PERMIT NO.
23607

CITY OF NEW BEDFORD
SEWER AND/OR STORM DRAIN PERMIT

Assessor's Plot 136 Lot 444, to the sewer and/or storm drain in Acushnet Ave. Street

I aim proposing a French drain be installed at the property owned by Mr. and Mrs. Glen Warrington known as Plot-136 Lot-444, foundation permit # 368204, Sewer and/or Storm Drain Permit #23607.

SKETCH PLAN

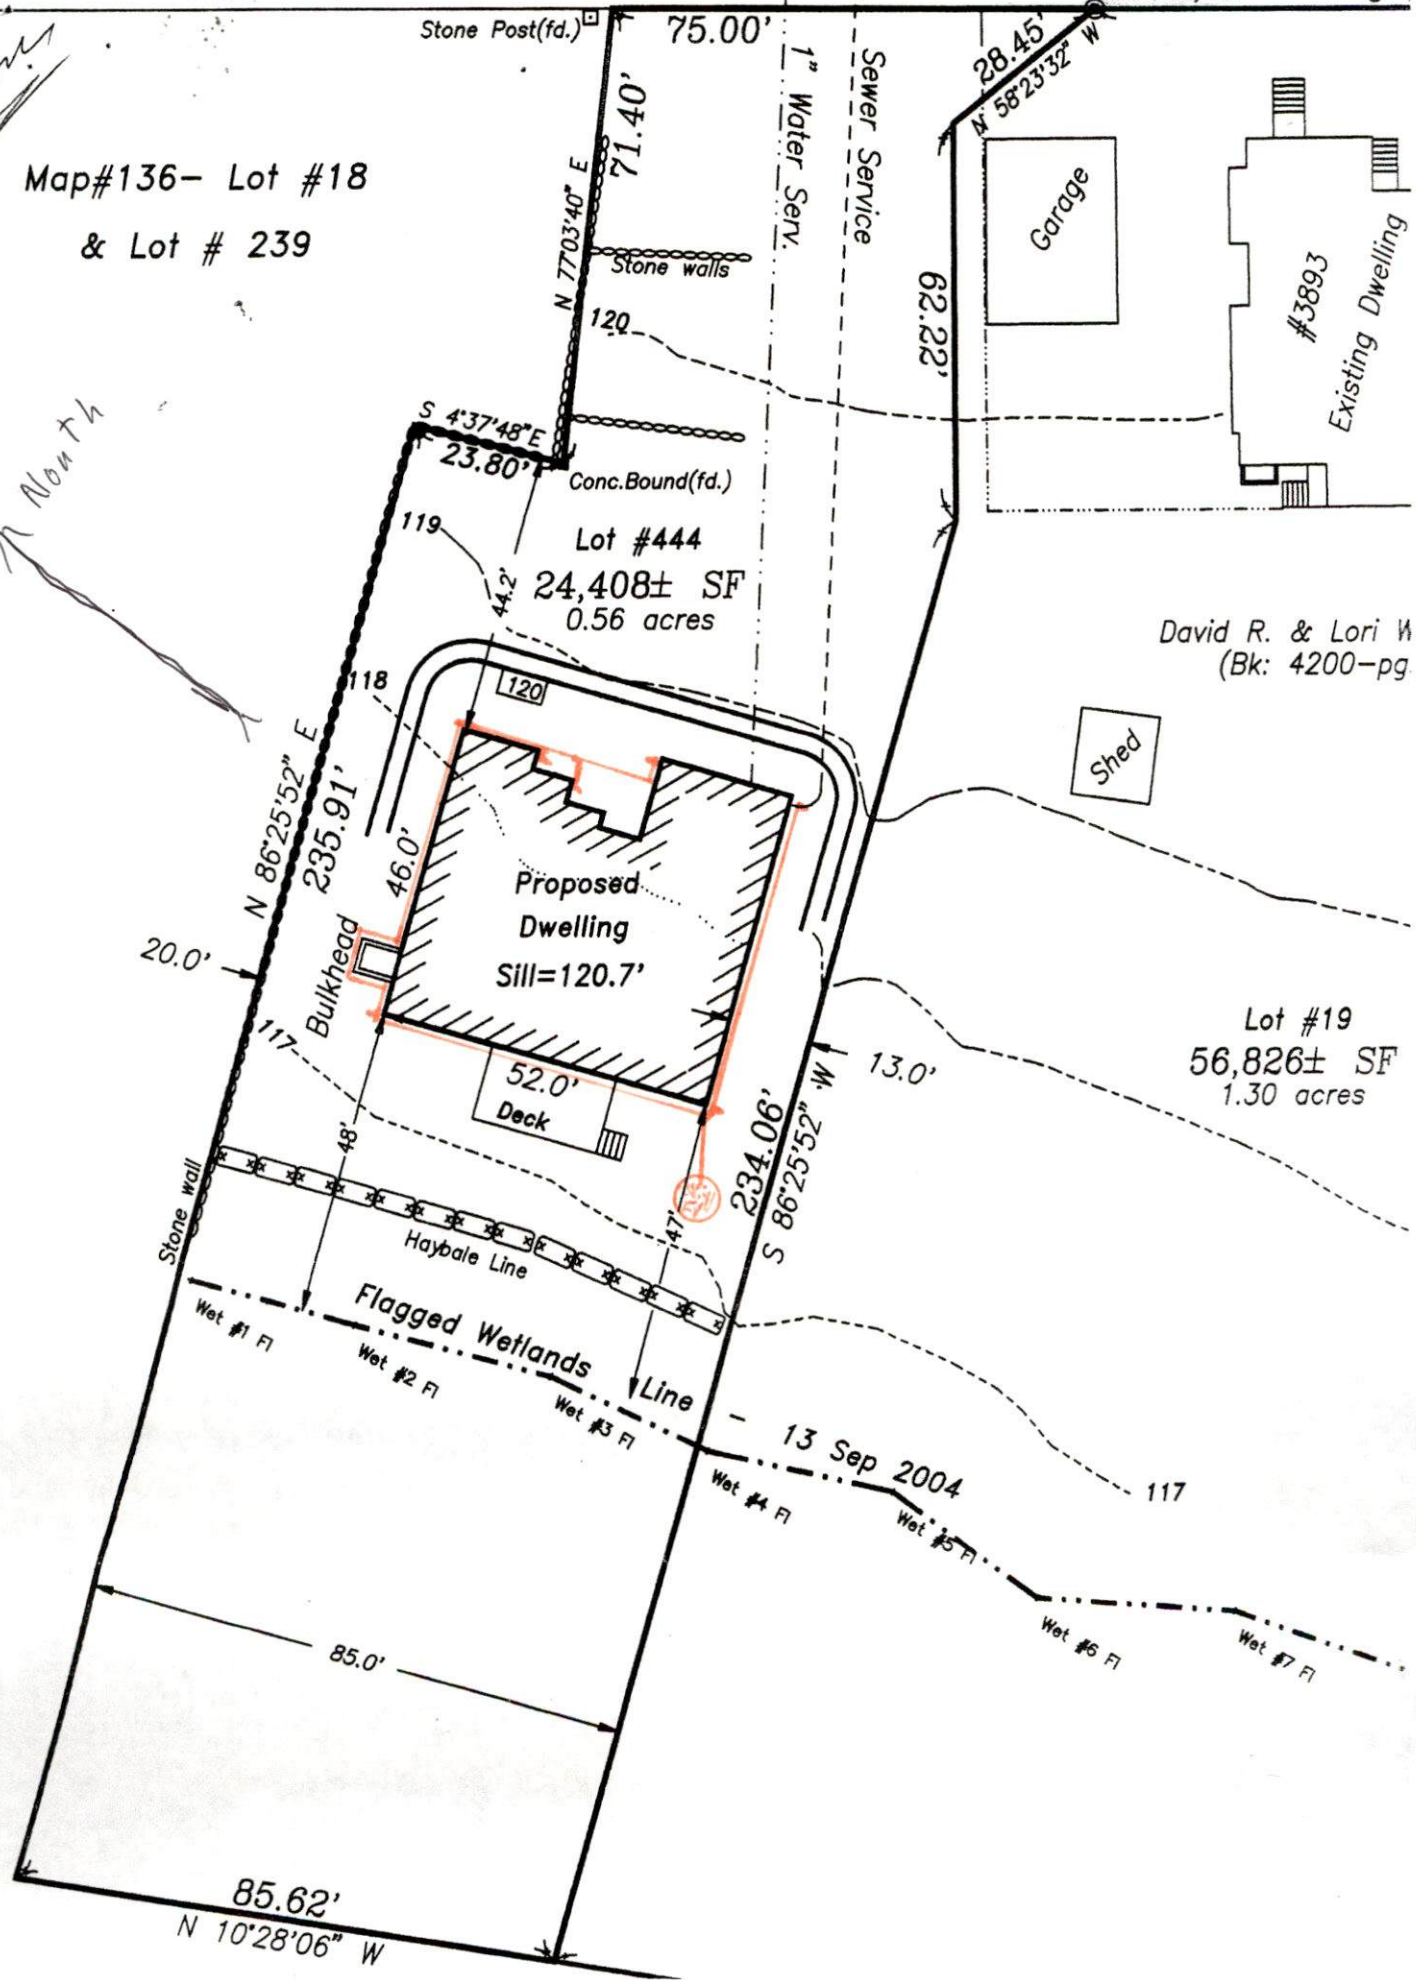
drain plot 211 - no pipe size for sewer

PRECAST DRYWELL or LEACHING BASIN

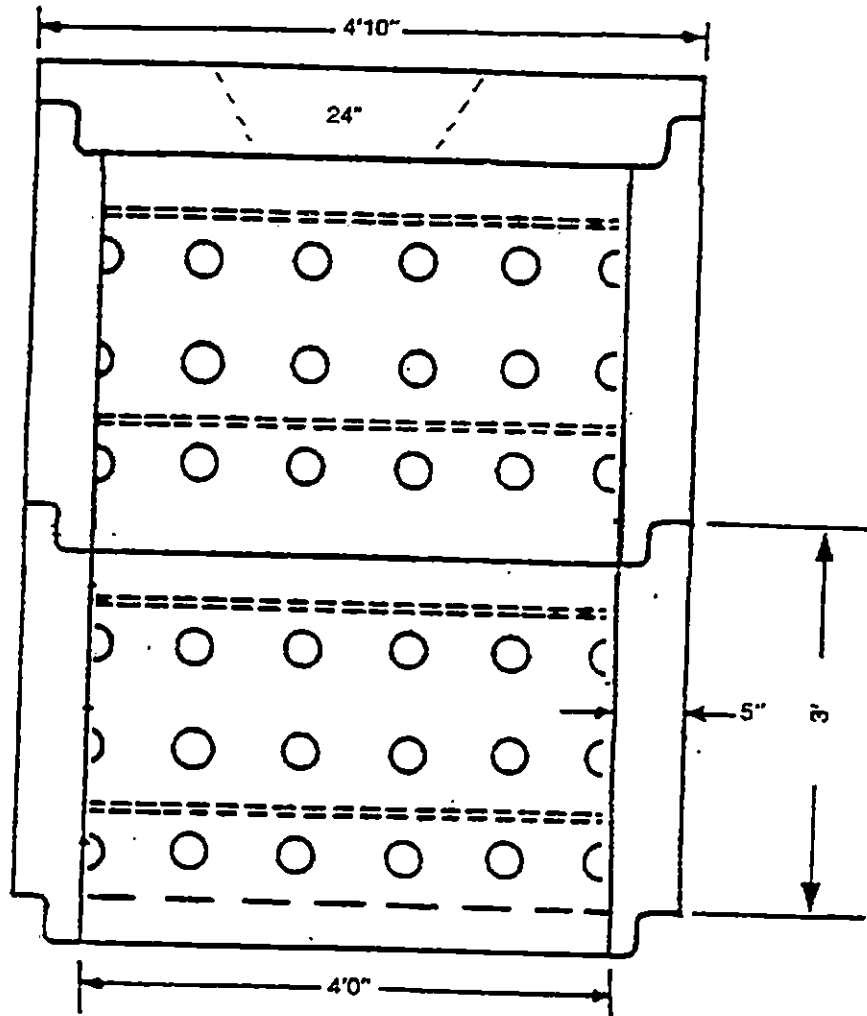
Other requirements: flowable fill, water and sewer services must be
10' apart, if storm drain is installed, it must be 2' from sewer line
and not above it. 24 hr inspection at 508-979-Connection made to ☒ Sewer ☐ Storm Drain Part of jointly-shared private line YES ☐ NO ☒ see attached 1527
dry well plan
* may provide plan to drain into private prop. with roof leaders
